PLANNING CLEARANCE

LIFT STATION FEE \$1,104
 Building Address 2659 LOOKOUT COURT
 Parcel No. 2945-244-41-048
 Subdivision SPYGLASS RIDGE
 Filing 1 Block N/A Lot 111

2659 Lookout Court
Grading and Drainage Plans
Page 1 of 4

2659 Lookout Ct
 Madeline Heinemann Residence
 Grand Junction, CO 81503
 Spyglass Ridge Subdivision

NOTES FOR DEEP & SHALLOW SUBSURFACE BARRIER/DRAIN

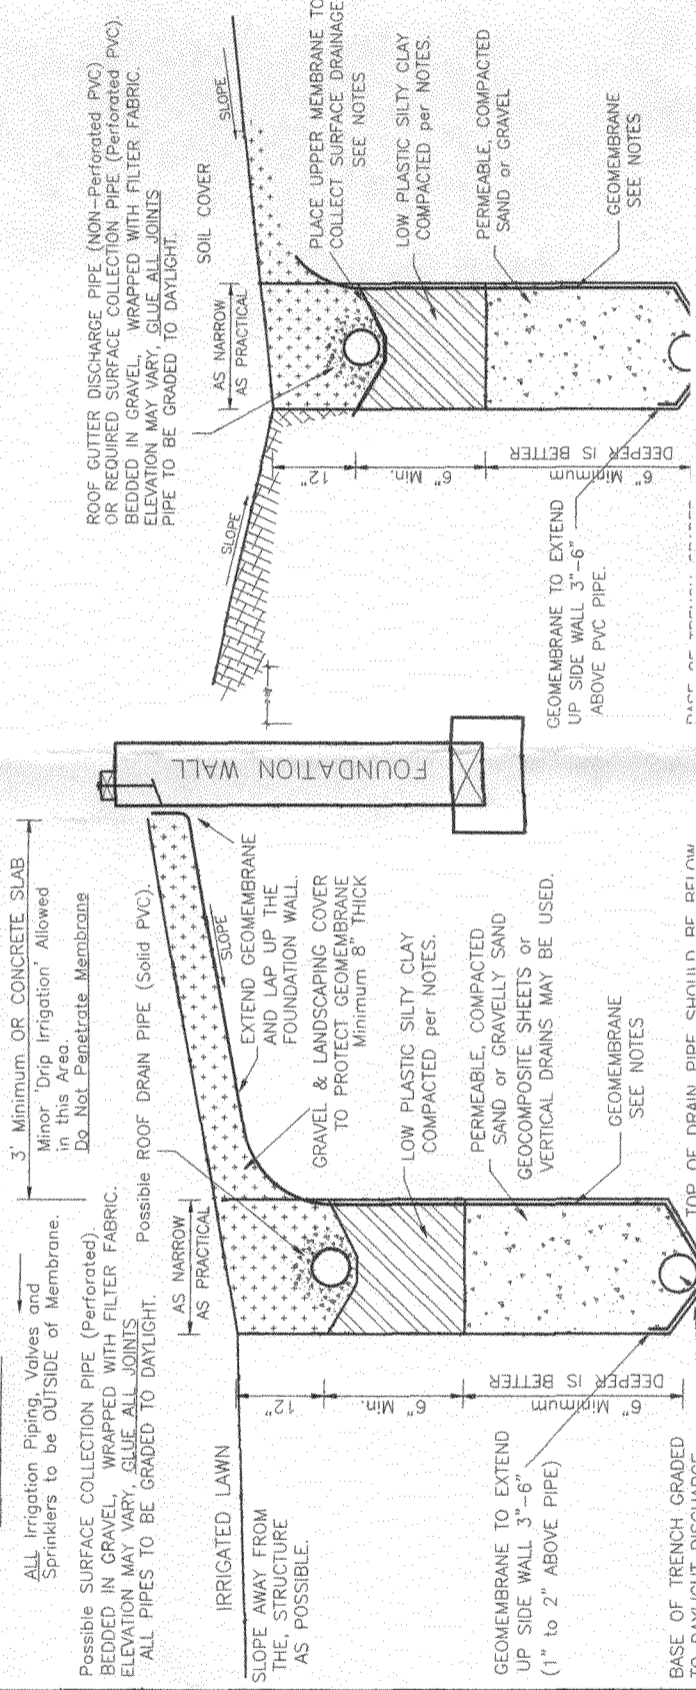
*City of Grand Junction
 Approval by 11/28/07
 for Drainage*

*This drainage plan was reviewed
 by Edward M Morris, PE.
 The Shallow Subsurface Drains
 details may be required for
 portions of this project.*
